MAS004988 RU 25-34

Rapid Update 807 GranTurismo Folgore – A-pillar replacement

DATE: January 02, 2026

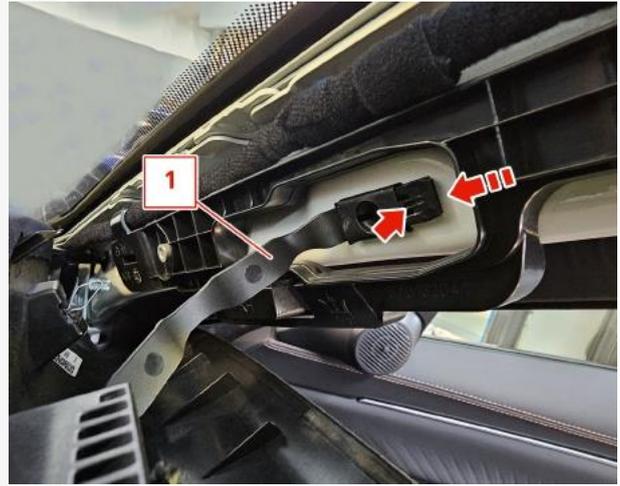
A batch of components intended for assembly may contain contamination, which could affect the positioning of the trim fabric and lead to visible wrinkles. This condition is cosmetic only and does not impact the vehicle's safety or functionality.

Fix: Replace the left windshield A-pillar trim.

1. Always check ModisCS+ to see if the vehicle is involved in this action and if it has not been previously performed.
2. Make sure you use all the precautions to work inside the vehicle and avoid any type of dirt from ruining the interior of the vehicle.
3. Replace the covers following the procedure in the workshop manual:
 - a. **9.44.002 LH WINDSCREEN PILLAR COVER. Removal-Refitting or Replacement**
